Source: TSG CN WG1
Title: CRs to Rel-6 WI MBMS towards TS 24.008 and TS 24.007
Agenda item: 9.8
Document for: APPROVAL

This document contains **9 CRs on Rel-6 Work Item “MBMS”**, that have been agreed by TSG CN WG1 CN#35 meeting and forwarded to TSG CN Plenary meeting #25 for approval.

Title:	⌘	Introduction of the MBMS Multicast Service Deactivation procedure – Reuse of PDP context deactivation messages	
Source:	⌘	Ericsson	
Work item code:	⌘	MBMS	Date: ⌘ 01/07/2004
Category:	⌘	B	Release: ⌘ Rel-6
		Use <u>one</u> of the following categories:	Use <u>one</u> of the following releases:
		F (correction)	2 (GSM Phase 2)
		A (corresponds to a correction in an earlier release)	R96 (Release 1996)
		B (addition of feature),	R97 (Release 1997)
		C (functional modification of feature)	R98 (Release 1998)
		D (editorial modification)	R99 (Release 1999)
		Detailed explanations of the above categories can be found in 3GPP TR 21.900 .	Rel-4 (Release 4)
			Rel-5 (Release 5)
			Rel-6 (Release 6)

Figure 6.5: Session Management service states at the SMREG-SAP for MBMS context handling - MS side

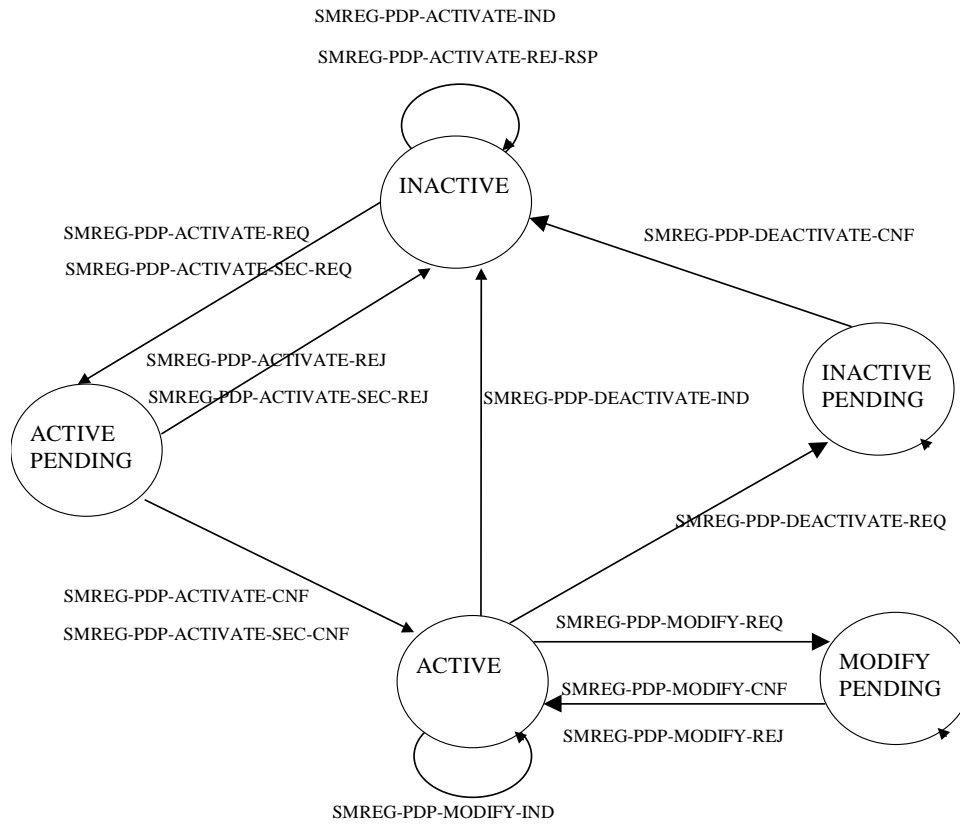
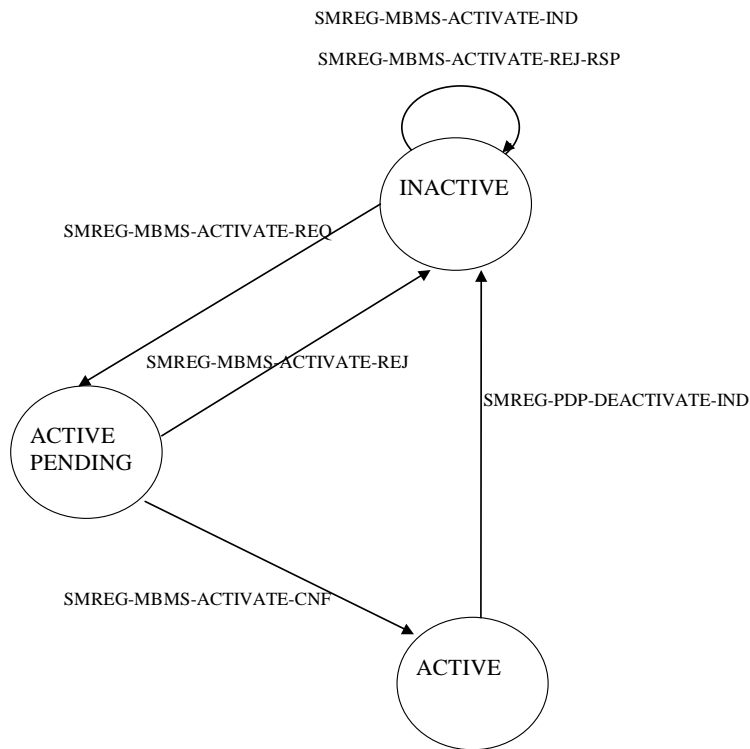
The ~~s~~Session ~~m~~Management services provided at the service access point SMREG-SAP are illustrated in the state machines of figure 6.4 and 6.5 below. Note, that ~~each~~the state machine describes only one PDP/MBMS context within the SM entity.
